## ADDENDUM NO. 2

Project: Clinton County Government  
Dewitt Annex – 2012 Renovations  
IIW Project No.: 11176-01

Issue Date: Monday, July 30, 2012

Addendum Drawing Issue Information:  
 Drawing No: P/AD2-1  
 Sheet: 1 OF 3  
 Date: 07/30/12  
 Drawn By: A&O  
 Project No: 11176-01

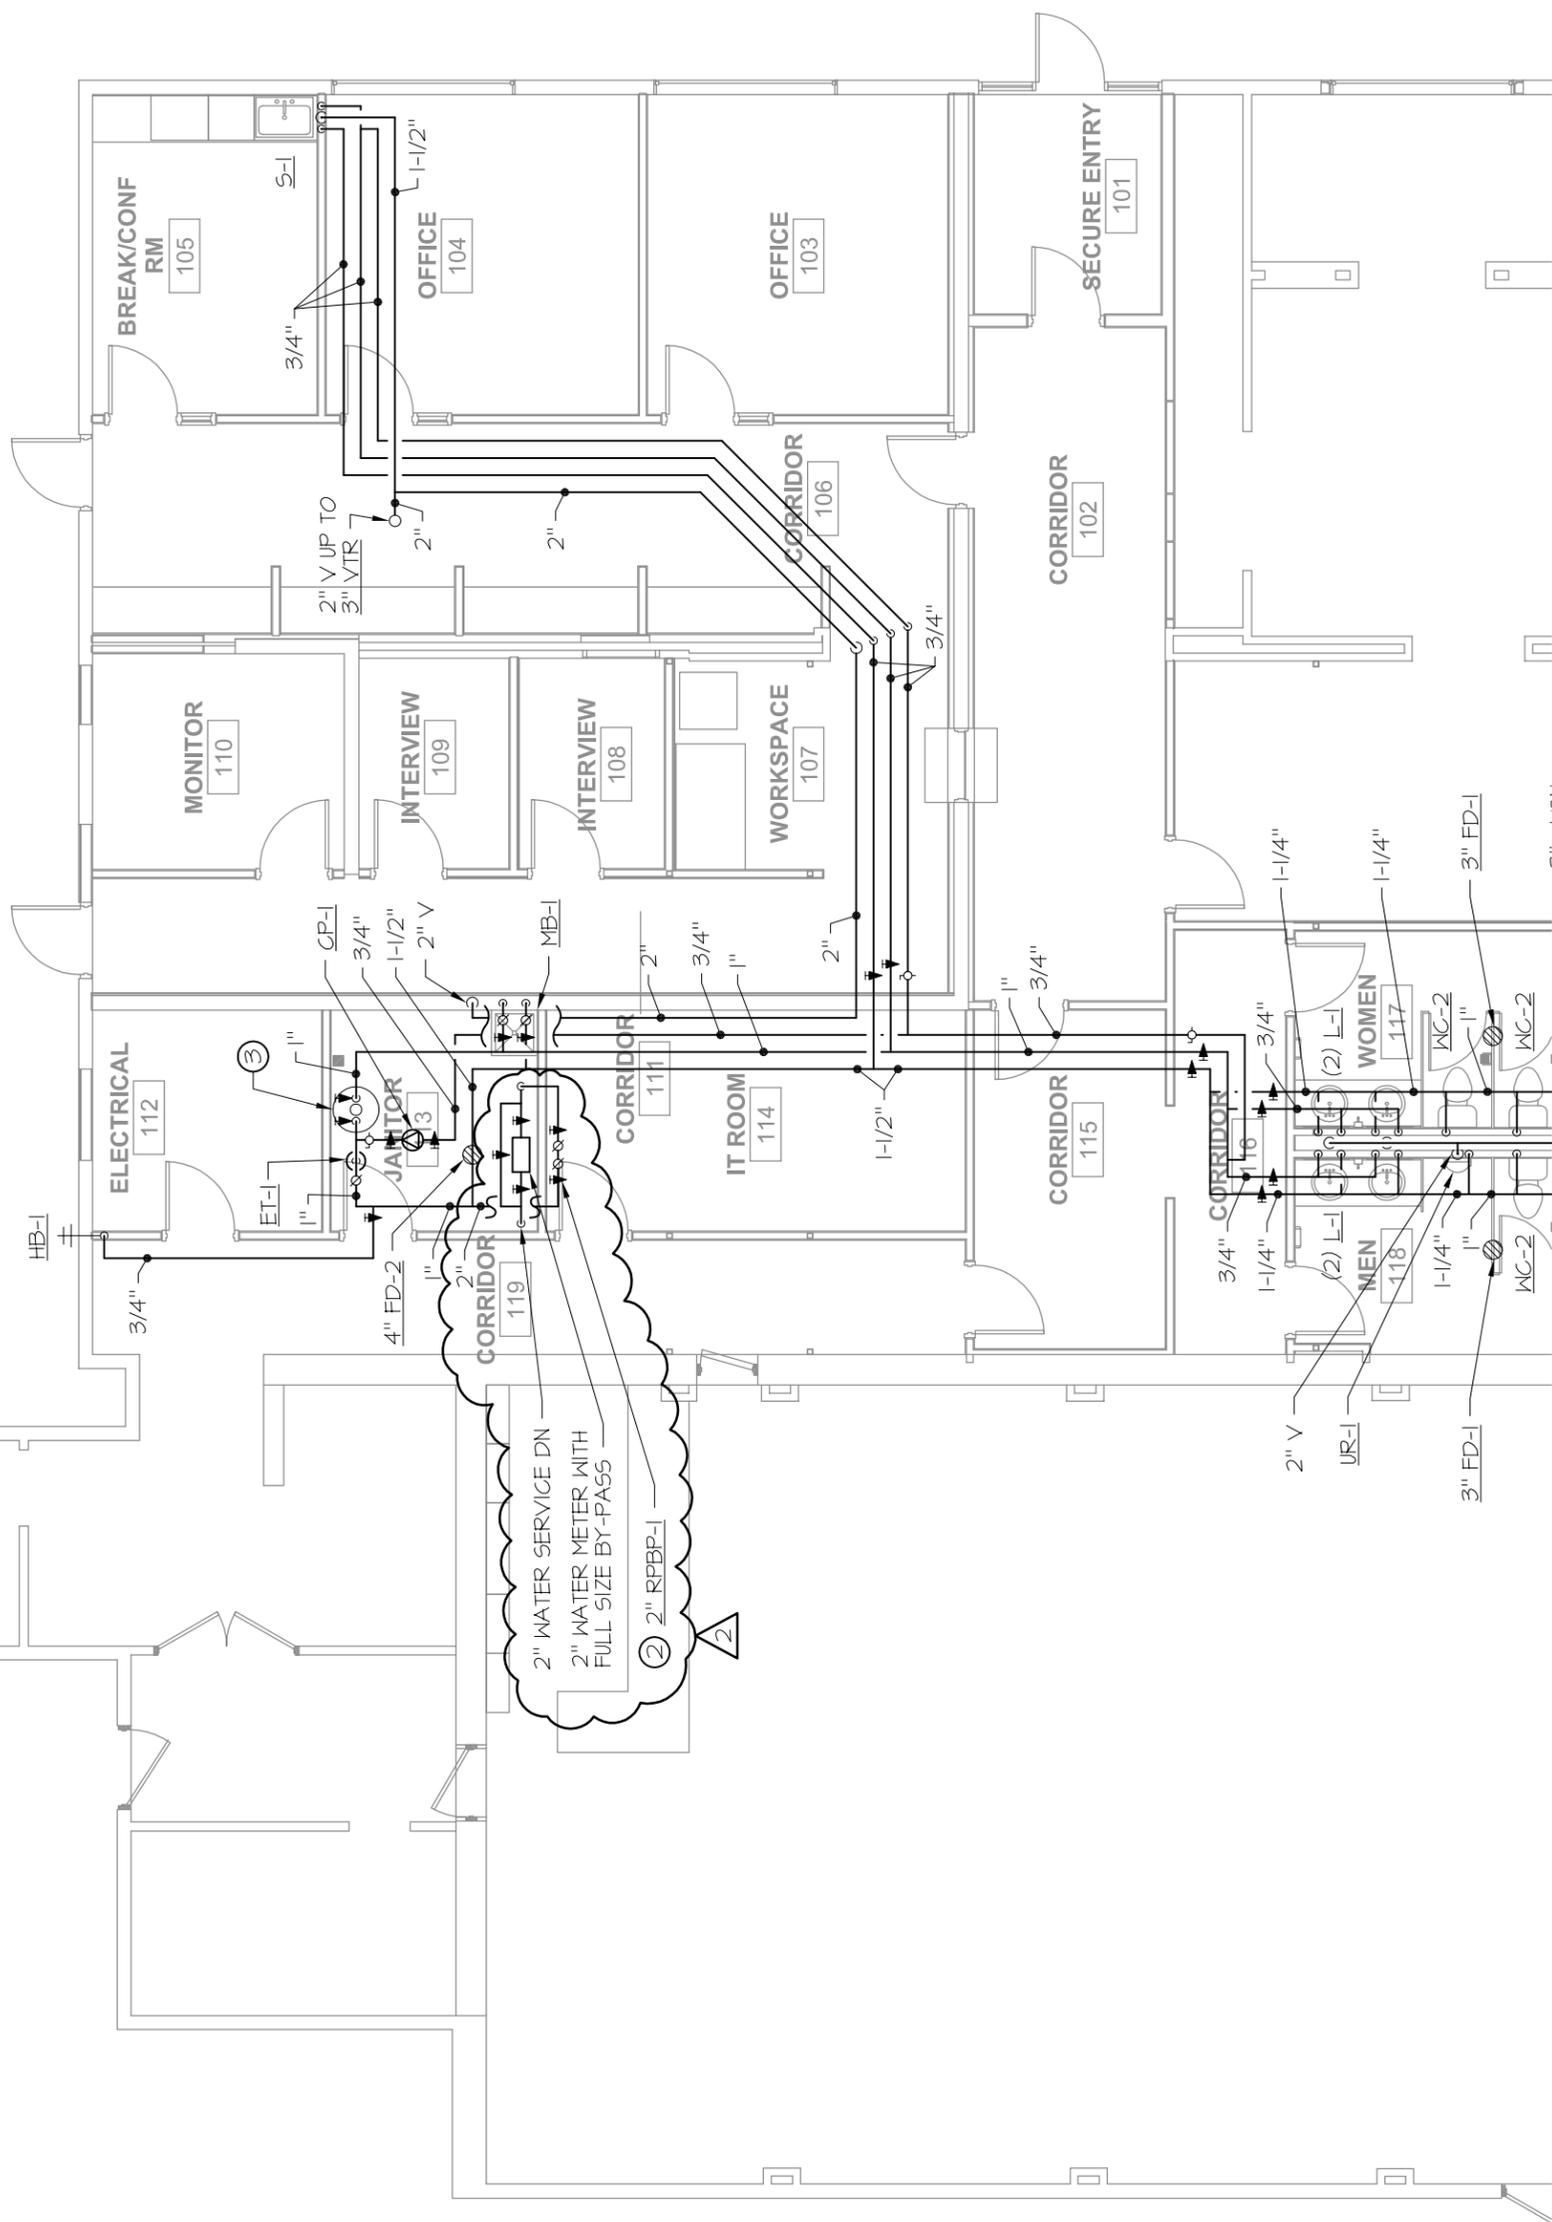
a. Add Keyed Note 4. Refer to drawing P/AD2-1.

b. Modified Underfloor Plan to include the new 2" water service and replacement of existing sanitary sewer that is in poor condition. Refer to drawing P/AD2-1.

- d. Add the following as a general Note to Underfloor Plan:
  - i. Plumbing Contractor is responsible for piping a new 2" water service from the existing 12" water main in 11<sup>th</sup> Street. Plumbing Contractor is responsible for installing all piping, valves, and accessories per the City Of Dewitt, Iowa water utility requirements. Plumbing Contractor is responsible for all cutting and patching of asphalt and concrete. Refer to drawing E1.0 for site conditions.

- ① PLUMBING FIXTURES AND ASSOCIATED PIPING IN THIS AREA SHALL BE ABANDONED IN PLACE.
- ② RBPB TO BE INSTALLED IN THE HORIZONTAL ABOVE THE WATER METER AND BY-PASS IN JANITOR I13.
- ③ RELOCATED EXISTING WATER HEATER.
- ④ REPLACE EXISTING SANITARY SEWER PIPING THAT IS IN POOR CONDITION WITH NEW SANITARY SEWER PIPING.

CONNECT NEW 2" WATER SERVICE TO EXISTING 12" WATER MAIN IN I11H STREET. REFER TO SHEET T1.1 FOR SITE CONDITIONS.

Addendum Drawing Issue Information:  
 Drawing No: P/AD2-2  
 Sheet: 2 OF 3  
 Date: 07/30/12  
 Drawn By: A&O  
 Project No: 11176-01

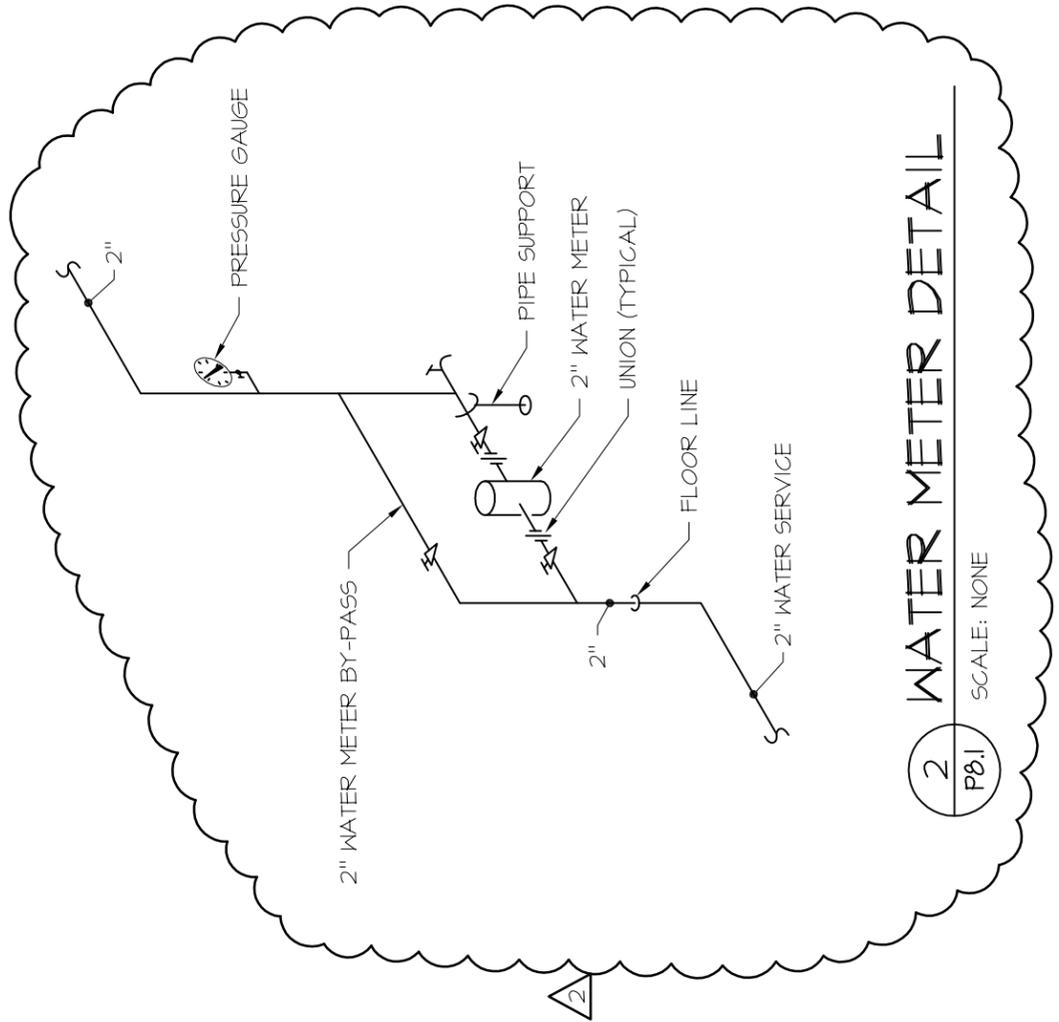
c. Modified Floor Plan to reflect changes required by change in water service size. Refer to drawing P/AD2-2.
